From: [Gardiner, Stephen](#)
To: [REDACTED]
Subject: CM: 40 Loughries Road
Date: 14 September 2023 11:44:02
Attachments: [40 Loughries Rd Lane Realignment.pdf](#)

40 Loughries Road - Lane Realignment

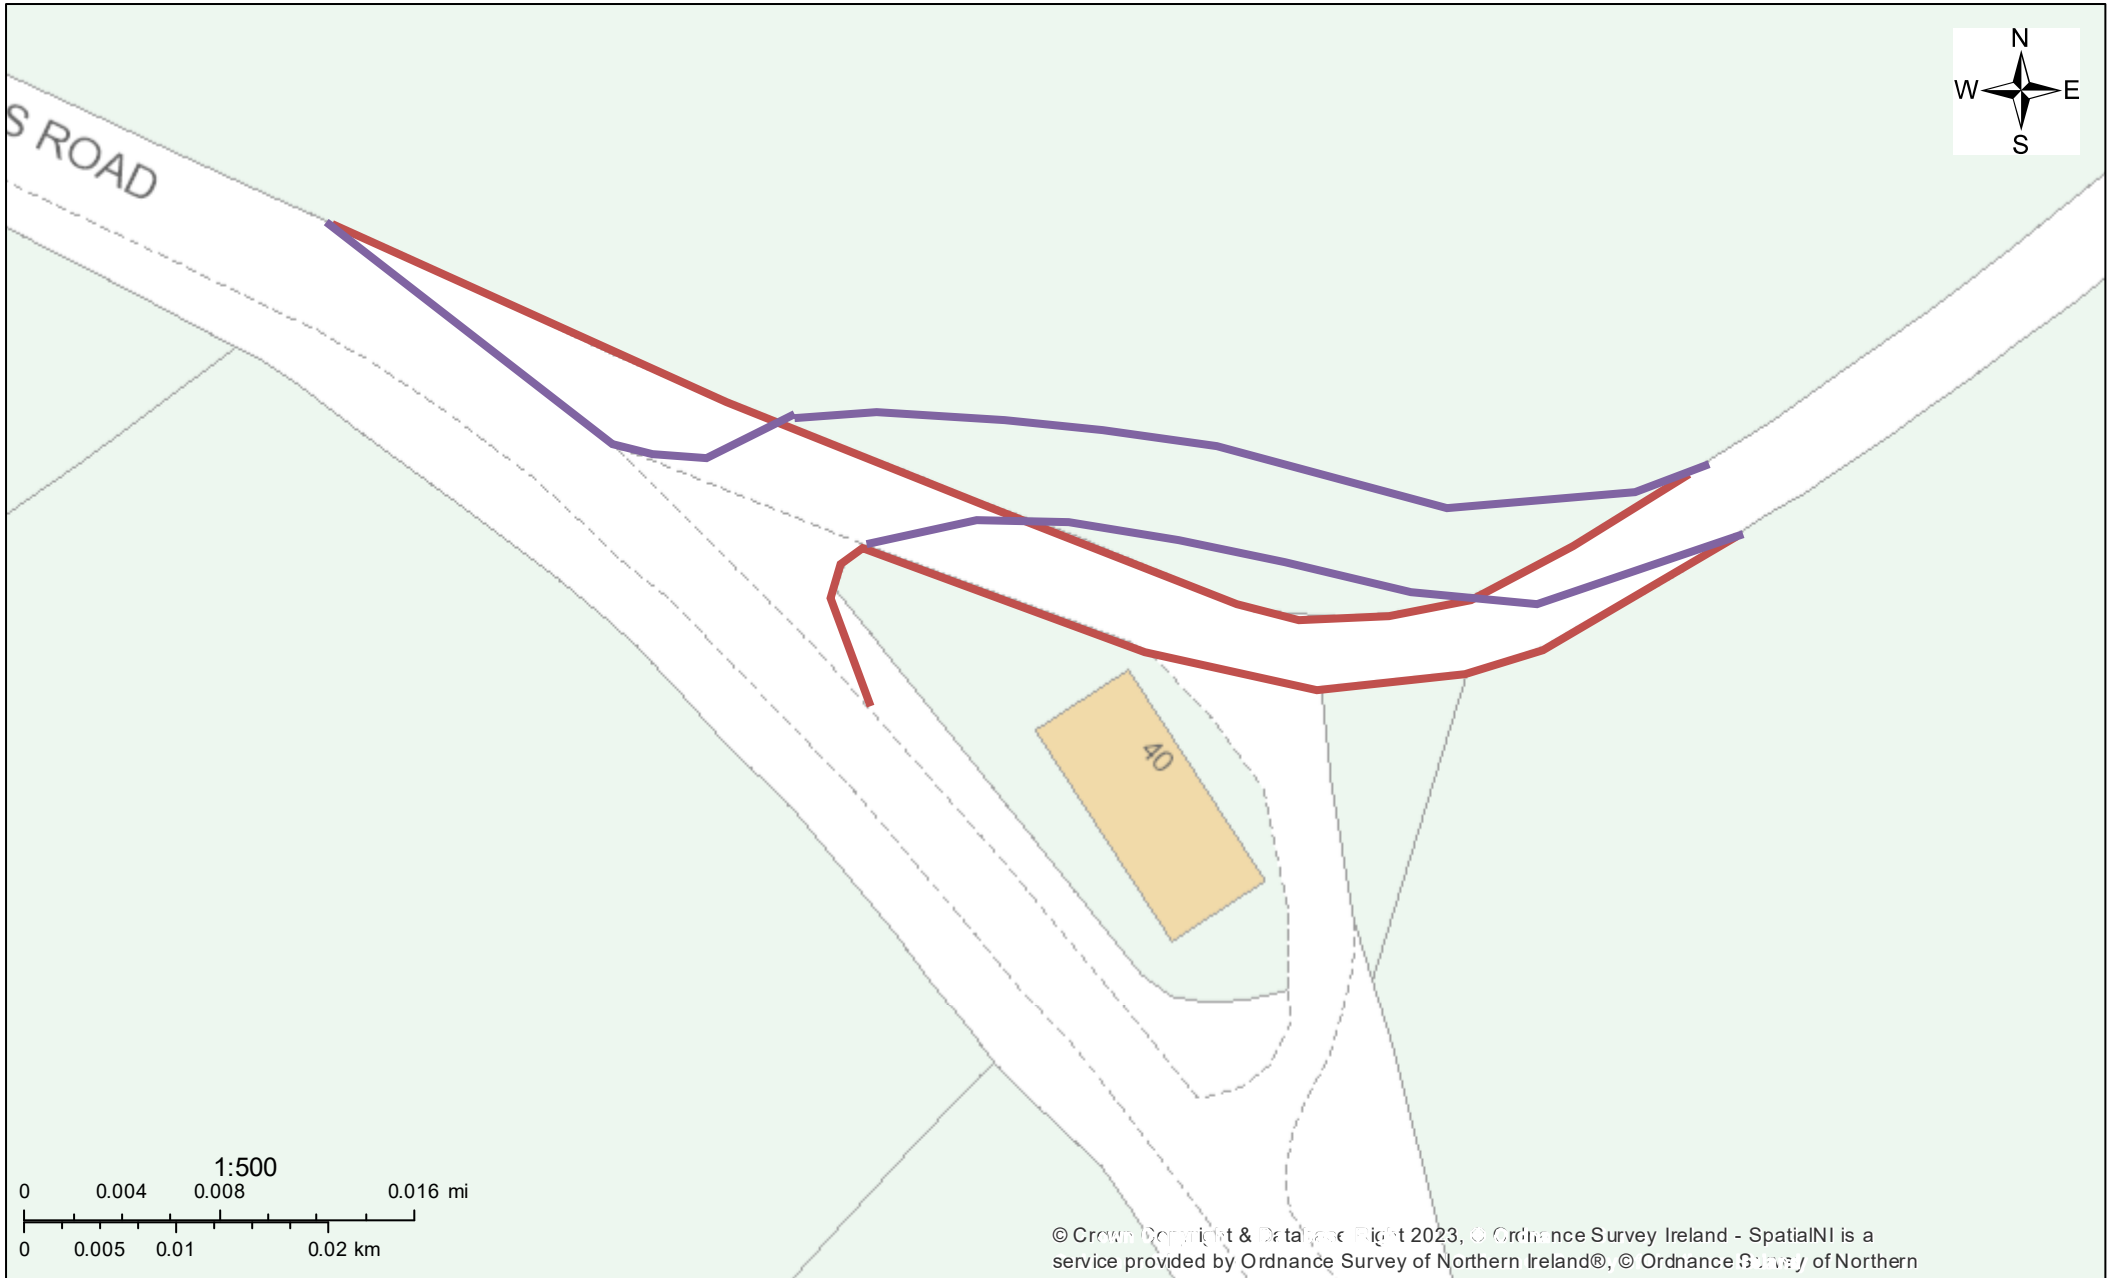
Please see attached, can you provide a drawing and swept path showing a kerblineline that will allow safe access and egress for a 7.5T box lorry.

Everything within the red line is potentially ours and would be the cheapest quickest solution.

I think however we will have to for a more traditional 'T' type junction (purple line) and land will be required.
